TENDER 16-20

WATER TREATMENT BUILDING

ADDENDUM NO. 3

September 30th, 2016

TITLE:	PROPOSED RAW WATER SUPPLY MAIN HIGHWAY #28 TREATMENT BUILDING - CONTRACT 2
DRAWING NO.	15-508- E101
PROJECT:	112311316
REV.	2

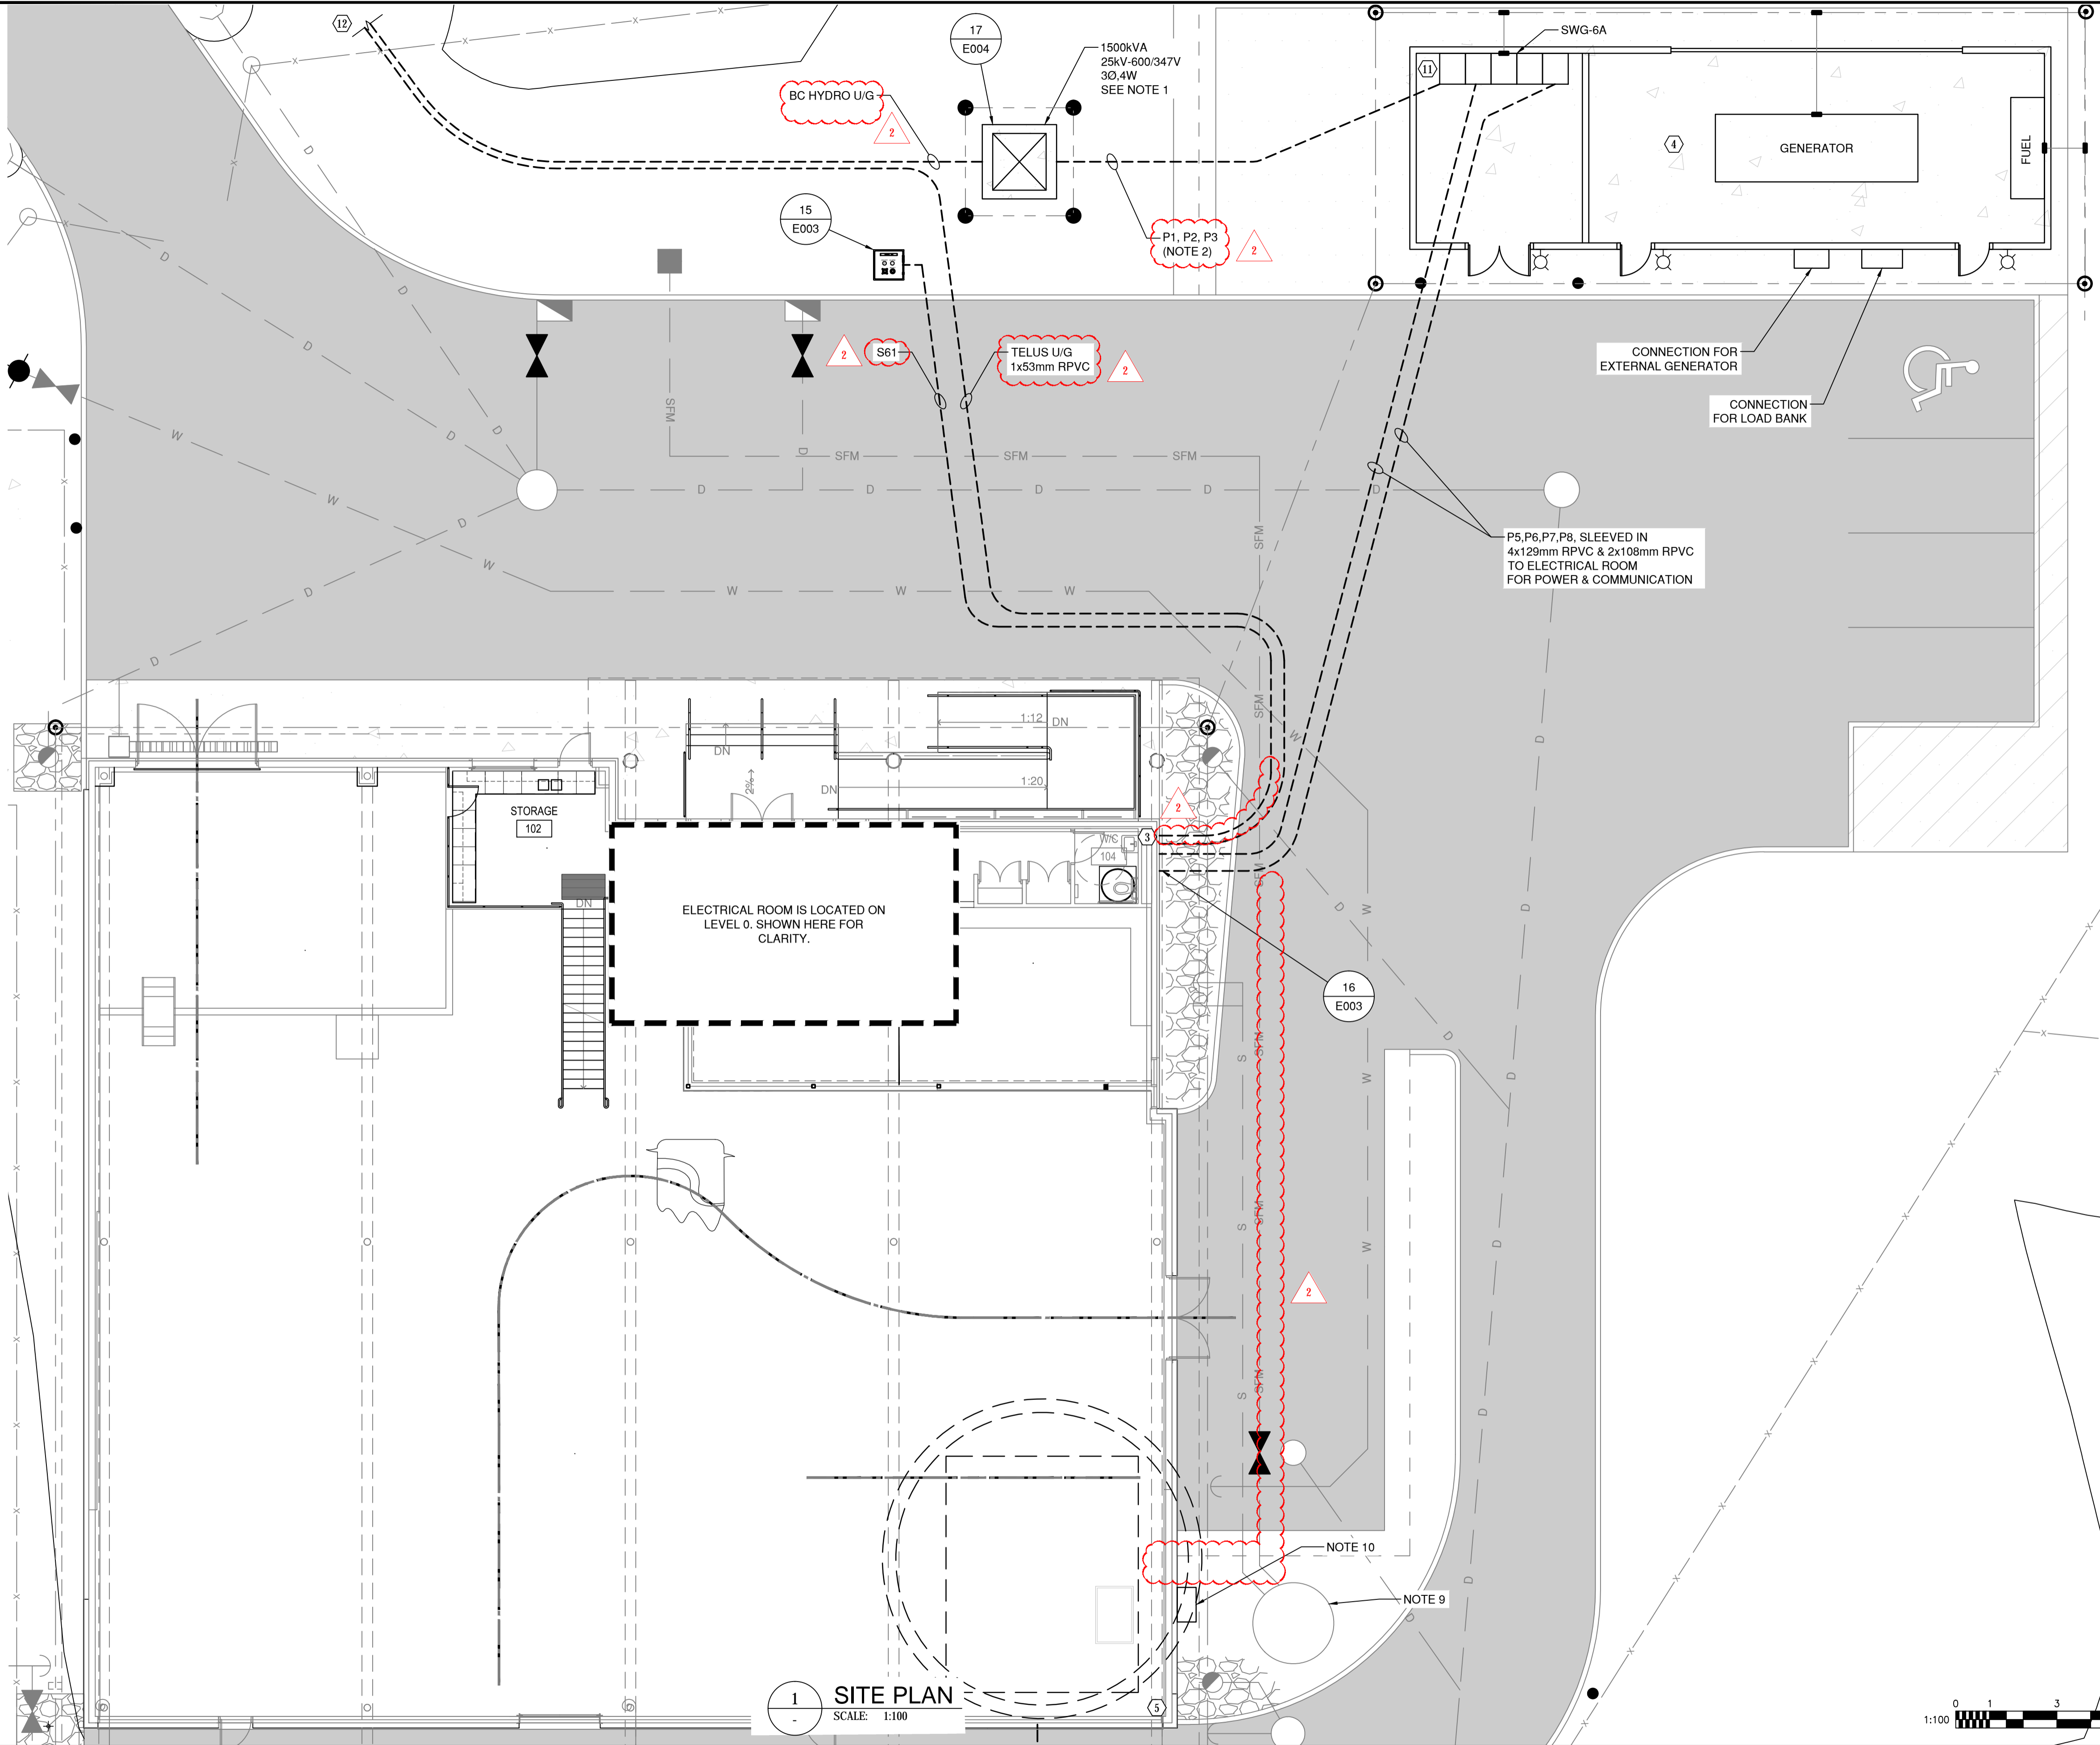
Please confirm that cable/conduit and wire P1, P2, P3, P1A, P1B, P1C, P1D and Telus U/G conduits into the water treatment building are all outside of the electrical contractor's scope of work. If it is with-in the electrical contractors scope of work please provide conduit and wire/cable sizes.

Please clarify/identify what conduit or cable feeding the waste pump control station as shown on drawing E101.

Drawing E101 note 9 references drawing C303. Drawing C303 shows three 50mm RPVC conduits that are not shown on the electrical drawings. It also talks about the Sanitary Storage Tank being shipped to site loose and electrical work to be completed by contractor. The electrical drawings seem to indicate that the electrical contractors scope of work ends at JB-901. If there is any electrical work to be done between JB-901 and the P-901 please identify the electrical scope of work along with the three 50mm conduits in question

- b. Drawing E101 revised to remove reference to P1A, P1B, P1C, P1D, and correctly identify P1, P2 and P3.
- c. Telus U/G conduit will be the responsibility of the Contractor. Reference E101 Note 12; assume 53mm DB2 Duct from site boundary to electrical room.
- d. Coordinate city communication conduit extension detailed on C103, Construction note 2.

Drawing E101 has been revised to identify Cable S61 and the proper routing of this cable. Note that additional cables are required between the waste tank and the electrical room, not specifically shown on E101.

The contractor is responsible for wiring, testing and commissioning the electrical and controls portion of the sanitary storage tank. Reference the cable schedule, single line diagram, control panel drawings and C303 to provide a functional system.
